### **CORRIGENDUM NO. 5 DATED 14-10-2021**

Tender Notice No: IPR/TN/PUR/TPT/ET/21-22/012 Dated 31st Aug 2021 for Supply, installation, testing, commissioning and site acceptance of the Containerized Data Center at IPR (Turnkey Project) as per the detailed specifications mentioned in the tender document

# Draft Layout (2) - Containerized Data Center (CDC)

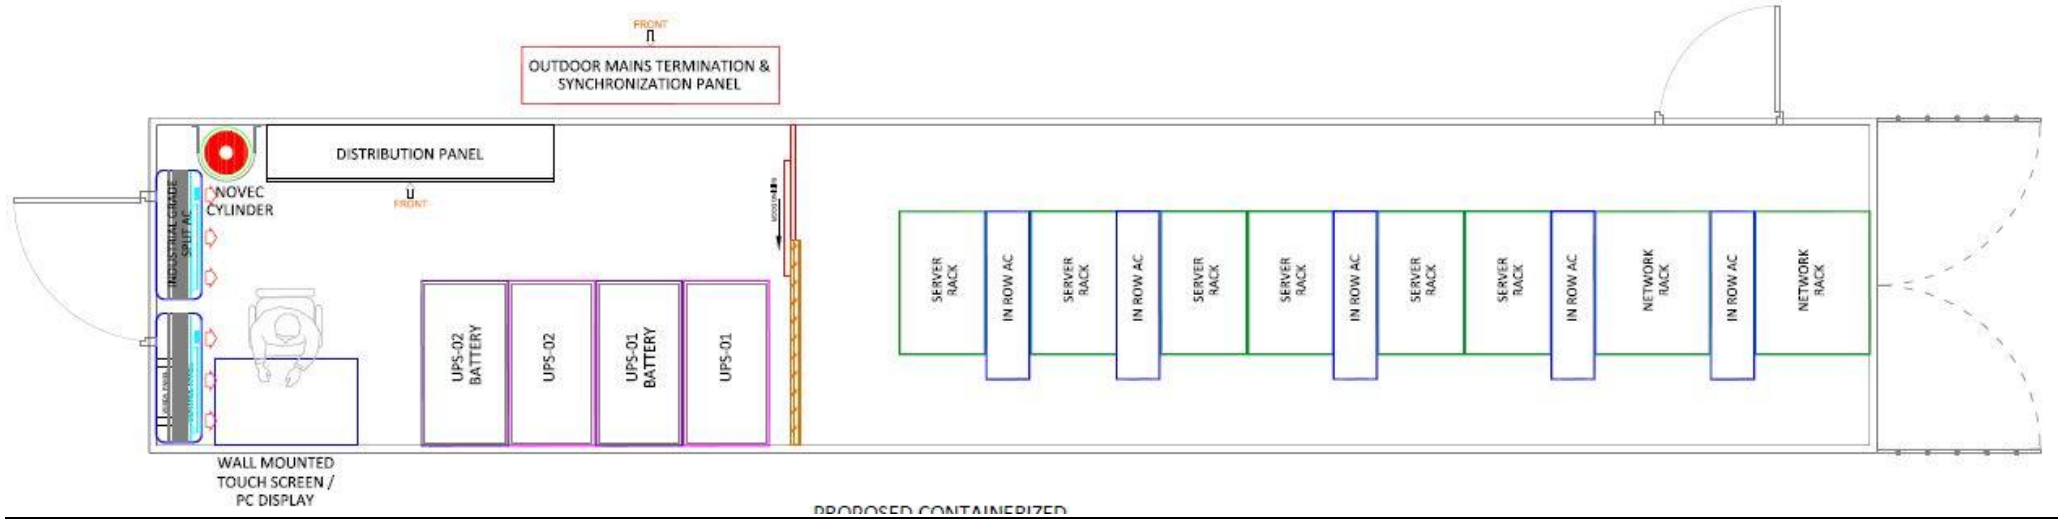
Serial Number	Clause	Tender Specification	Addition
1	<b>Addition</b>	General: Draft Layouts	Addition: Two draft layouts are attached below for better understanding of the requirement.
2	ANNEXURE-B [07] NETWORK / SERVER RACK SPECIFICATIONS	Blanking Panels	Following tool-less blanking panel quantity should be supplied with the racks: 1 U x 160 nos <b>OR</b> 2 U x 80 nos.
